Process Sheet

Customer	: CU-DAR001 Dart Helicopters Services	Drawing Name	: FLOAT WEB
Job Number	: 24862		
Estimate Number	: 10791		
P.O. Number	: <i>NIA</i>	Part Number	: D3282041
This Issue	: 11/21/2005 S.O. No. : <i>NIA</i>	Drawing Number	: D3282 REV C
Prsht Rev.	: NC	Project Number	: <i>NIA</i>
First Issue	: <i>NIA</i> Type : MACHINED PARTS	Drawing Revision	: C
Previous Run	: <i>NIA</i>	Material	: <i>NIA</i>
Written By	: <i>SEE COMMENT BELOW</i>	Due Date	: 12/20/2005 Qty: 10 Um: Each
Checked & Approved By	: <i>SEE COMMENT BELOW</i>		
Comment	: Est Rev:B 05.09.23 Procedure change KJ/JLM

FIRST ARTICLE INSPECTION CHECKLIST

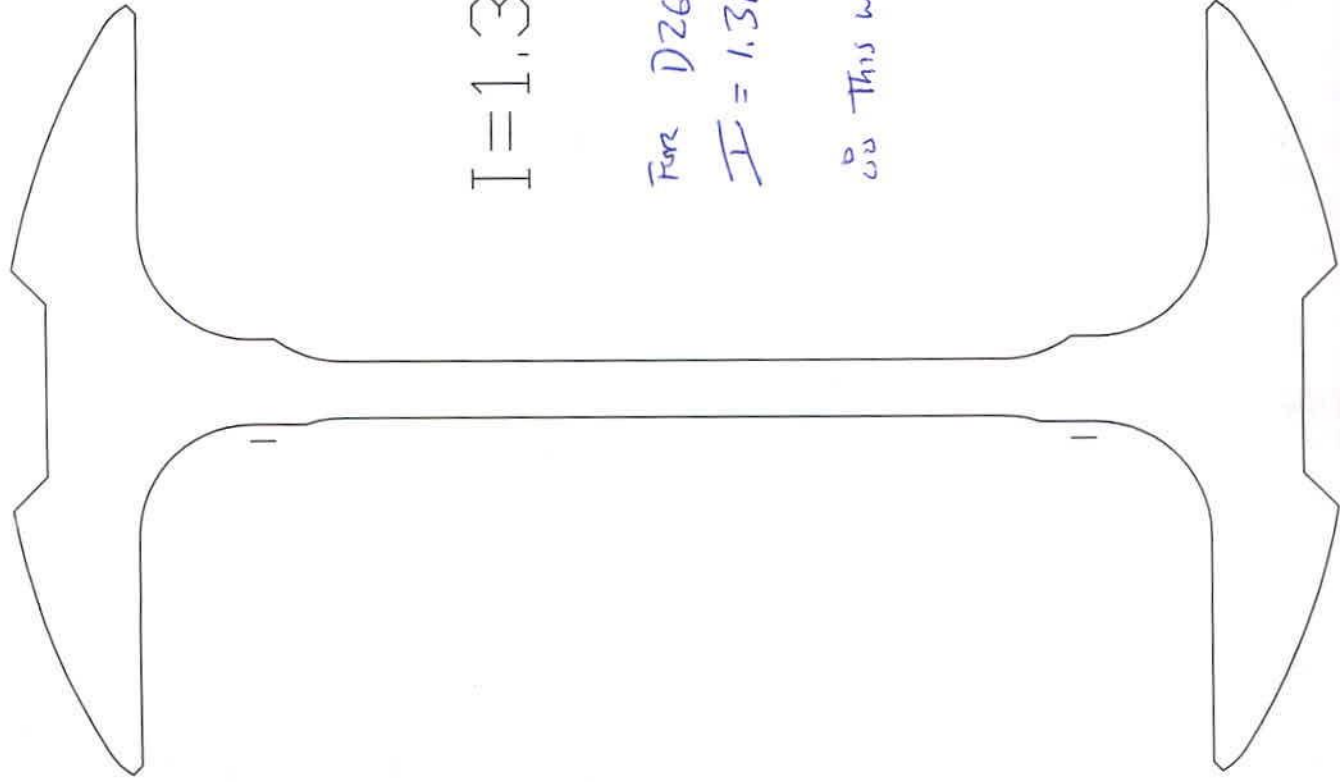
If you recall, a D3282 web was cut too deep. Basically the 0.050" relief from section A-A of drawing D3282 Rev. C was instead cut too 0.014" on one side only. My calculations show the inertia value (1.369) is still higher than the D2600-7 (1.318).

The reduced section is from the aft holes of the mid bag (section A-A), through the transition from section A-A to B-B.

The potential problem I see is that the transition is very pronounced (see attached pictures). This transition is at the point where the section jumps from 0.014" thickness to the 0.050", near the aft end of the mid bag holes.

If the transition from 0.014" to 0.050" is the radius of the cutter, then I think this is an acceptable deviation.

$$I = 1,369 \text{ in}^4$$

For D2600-7

$$I = 1,318 \text{ in}^4$$

∴ This web still stronger
